CENPD-283-NP-A

Boiling Water Reactor Emergency Core Cooling System Evaluation Model:

Code Sensitivity for SVEA-96 Fuel

SAFETY EVALUATION BY THE OFFICE OF NUCLEAR REACTOR REGULATION
RELATING TO TOPICAL REPORT CENPD-283-P
"BOILING WATER REACTOR EMERGENCY CORE
COOLING SYSTEM EVALUATION MODEL:
CODE SENSITIVITY FOR SVEA-96 FUEL"

Figure A9-7 Core Void Fraction at 20 Seconds versus Core Elevation

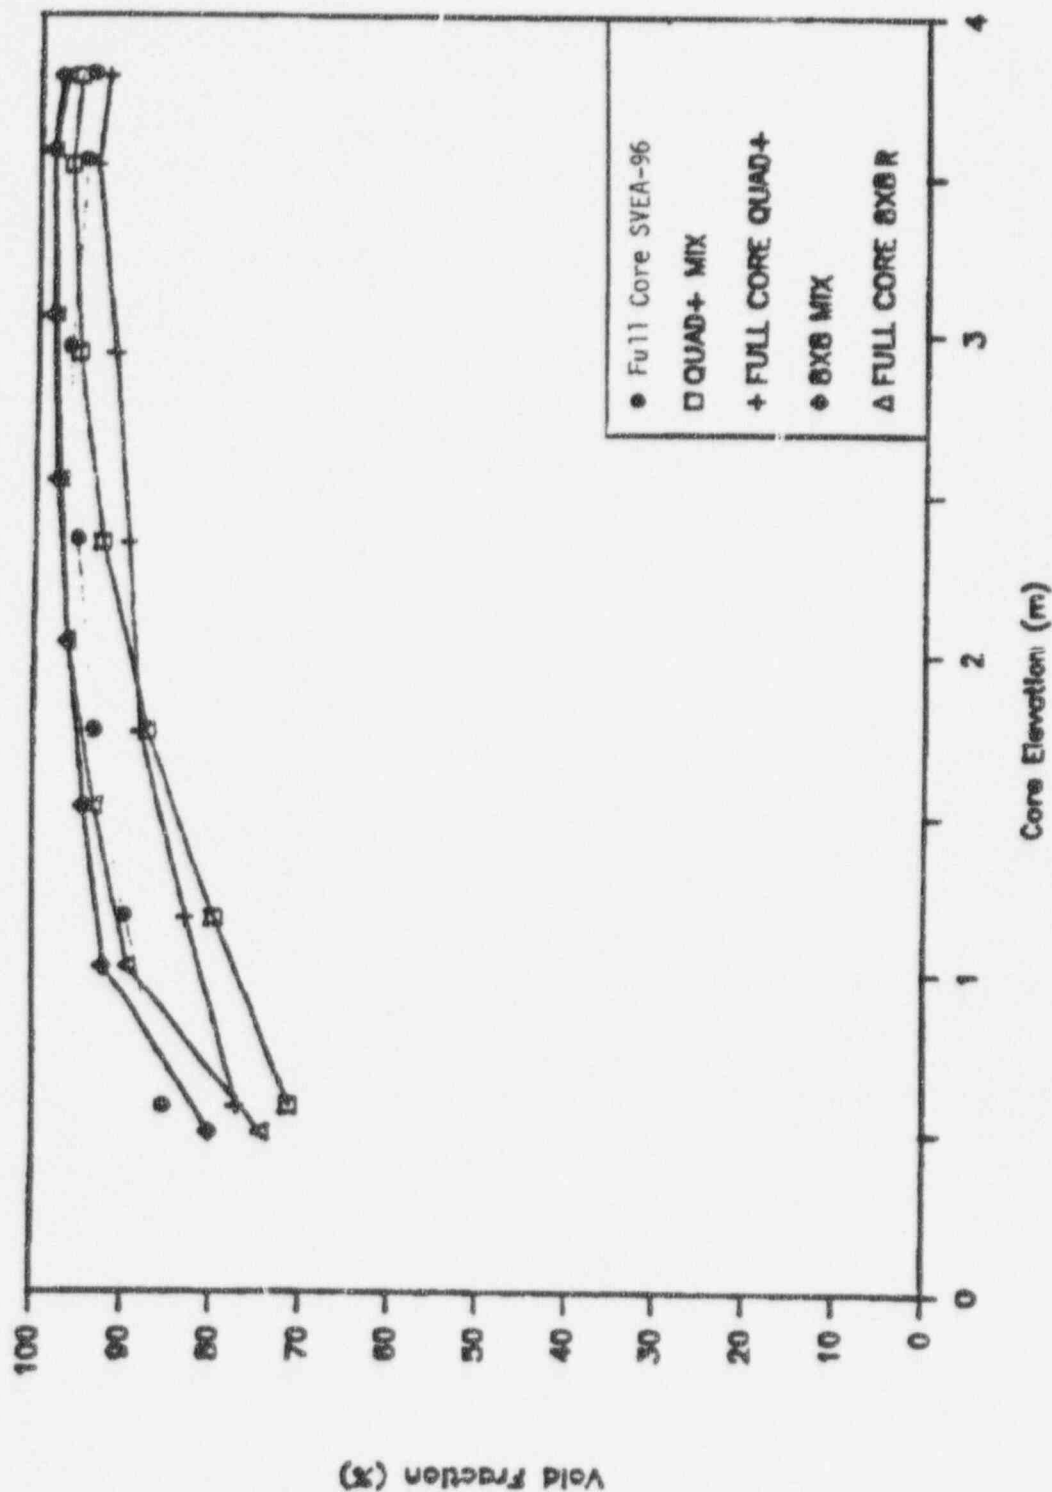
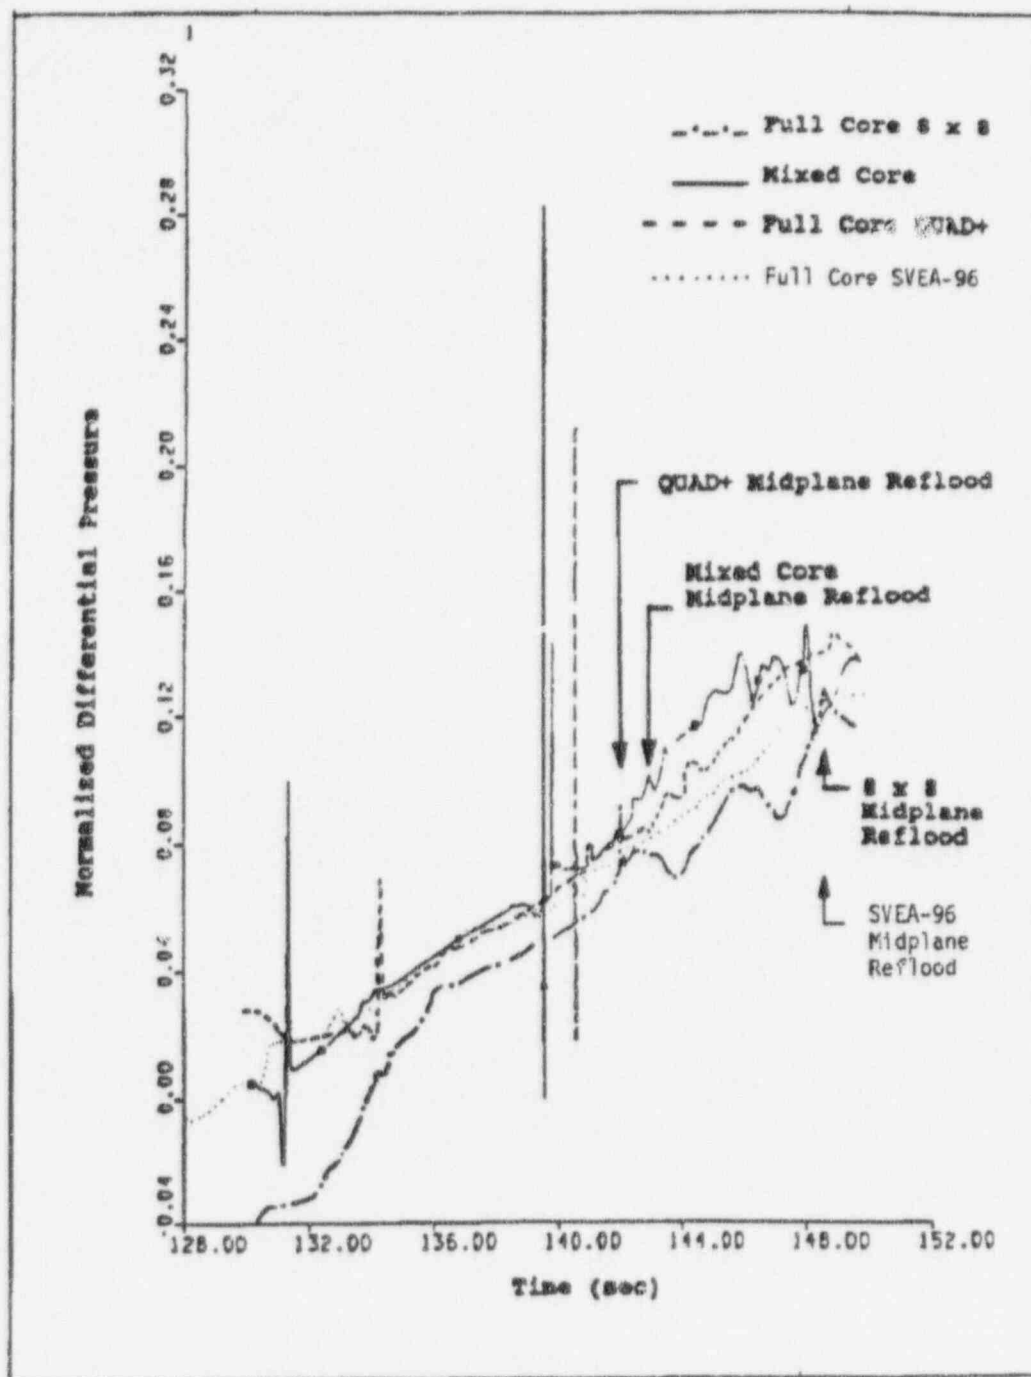
Mixed core effects should be investigated further to support ABB/CE's position regarding the transition cores by presenting mixed core analysis results with transition from QUAD+/SVEA64 fuel to SVEA-96 fuel. The watercross for each fuel design should be explicitly modeled in the nodalization. Provide plots from core void fraction, pressure, flow, and flow velocities.

To further demonstrate that the discussion presented and conclusions drawn in the response to Question 5 of RPB-90-94-P-A are valid in general, the results for a full core of SVEA-96 were compared to the previous system responses in Section 8 of this report. Additional comparative results are shown in Figures A9-1 through A9-8 which correspond to Figures 5-1 through 5-8 on pages 18 through 25 of the Addendum to RPB 90-94-P-A. The core compositions in the four cases presented in Figures A9-1 through A9-8 are:

For the Mixed Core case, as applicable, both QUAD+ and 8x8R channel results are shown in the figure. There are insignificant differences between the system responses of the four cores presented.

As discussed in Response 5 of RPB-90-94-P-A small differences in the responses are attributed to differences in fuel component designs. As noted in Response A1 of this document, the SVEA-96 core used as an example was not specifically designed to be hydraulically comparable with the previous example cores (i.e., QUAD+ and 8x8). Hence, in some instances in Figures A9-1 through A9-8, the SVEA-96 results deviated slightly more than those observed for the other cores configurations. However, the overall system responses are very similar.

The results presented here further substantiate the general conclusion that the core average system response is relatively independent of local differences in fuel assembly design.
